April 30, 2007

Subject: *Response to Comments on Proposed Plan for SWMUs 1 and 24*  
Naval Air Station Oceana  
Virginia Beach, Virginia

### Naval Air Station Oceana Virginia Beach, Virginia

**Figure 4-1-3**  
 WATER TABLE ELEVATIONS WITH  
 EQUIPOTENTIAL CONTOURS  
 FOR THE SHALLOW AQUIFER  
 AT SITE 1  
 JANUARY 26, 1993

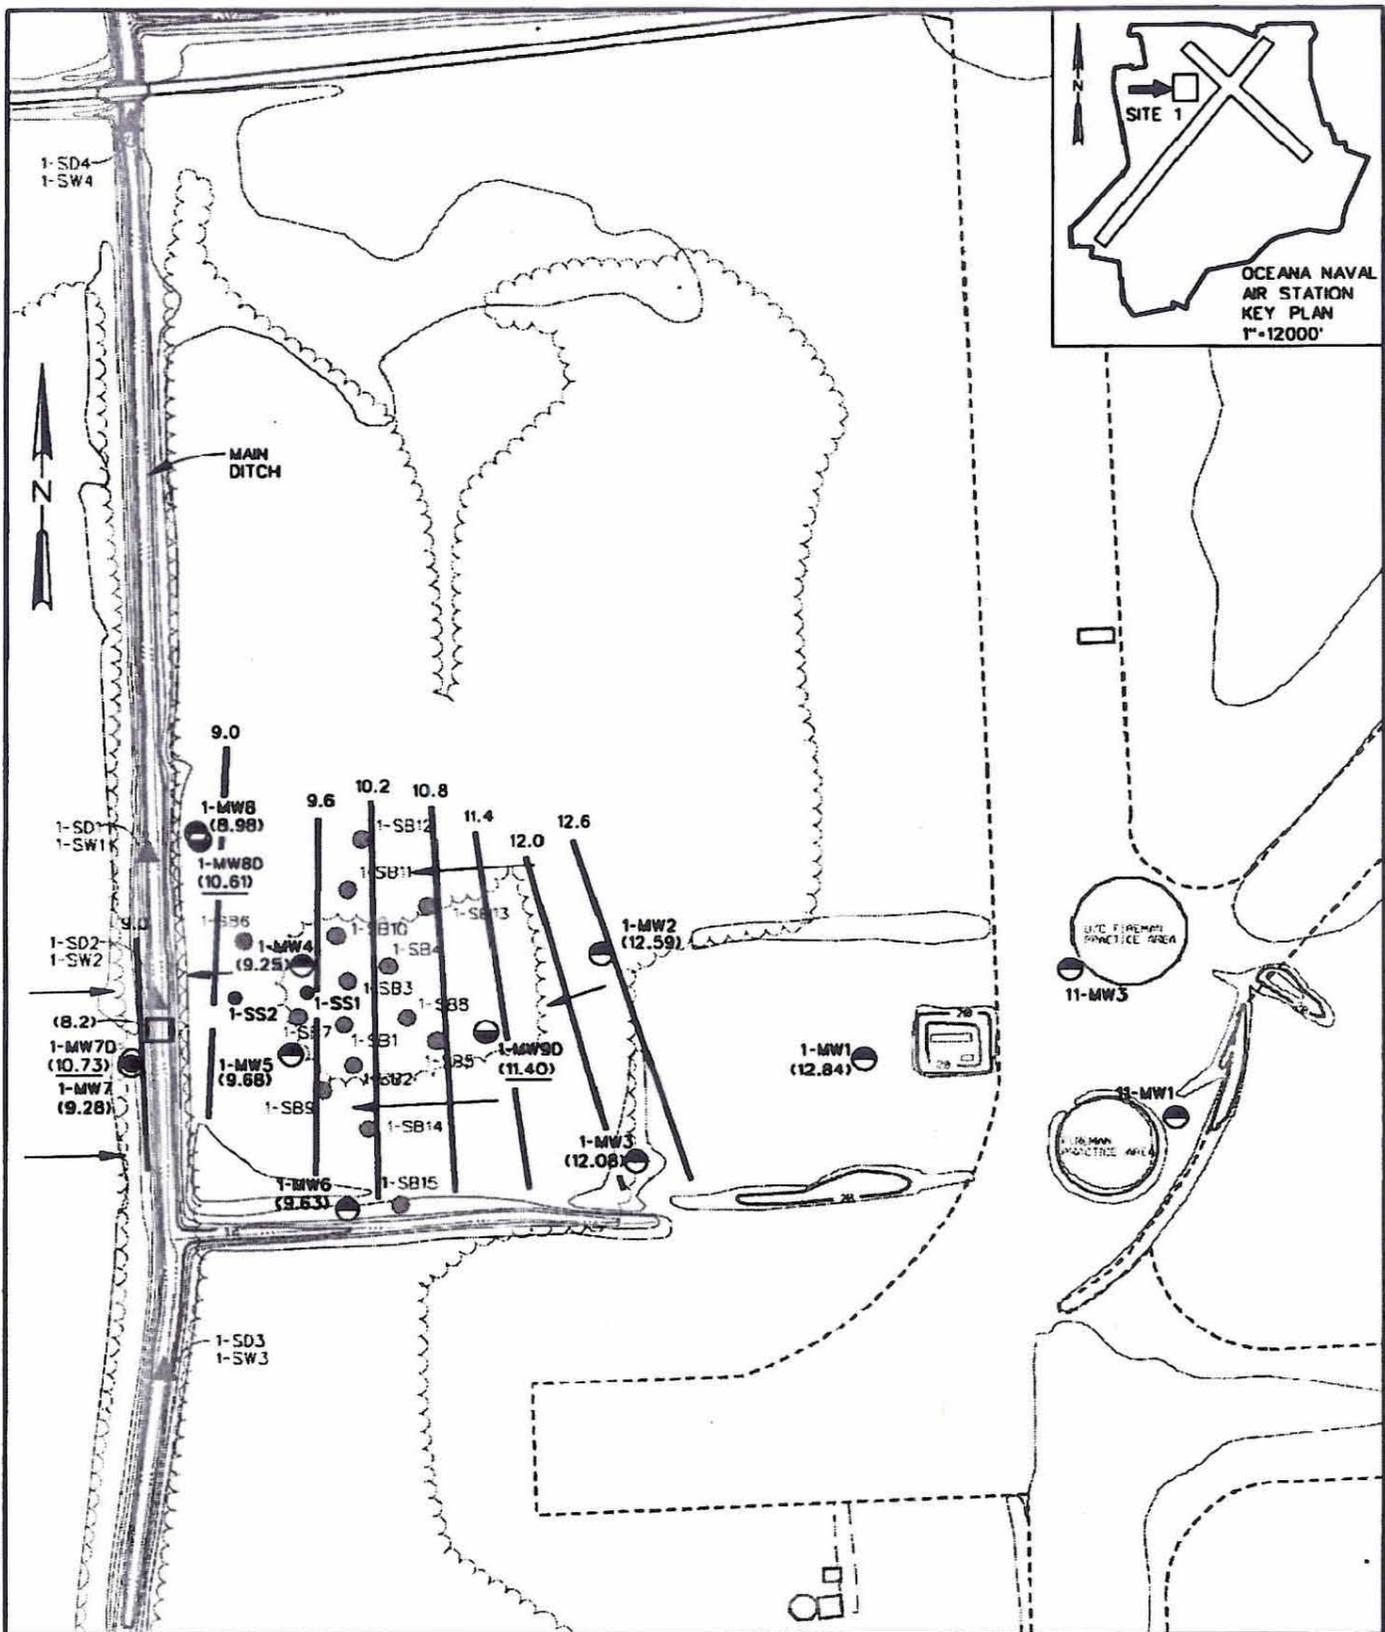
*Also, in the first paragraph, please change the reference to Figure 2, but then provide a more detailed figure, like figure 2-4 in the decision document, to indicate the distribution of benzene, naphthalene, and floating product at SWMU 1.*

24. *Figures 2 and 3. Please replace these figures with more detailed figures as mentioned in earlier comments.*

The figure was edited as requested.

Figure 4 has been added to show the arsenic concentrations. Figure 2 has been edited to provide more detail regarding concentrations of naphthalene, benzene, and free product.
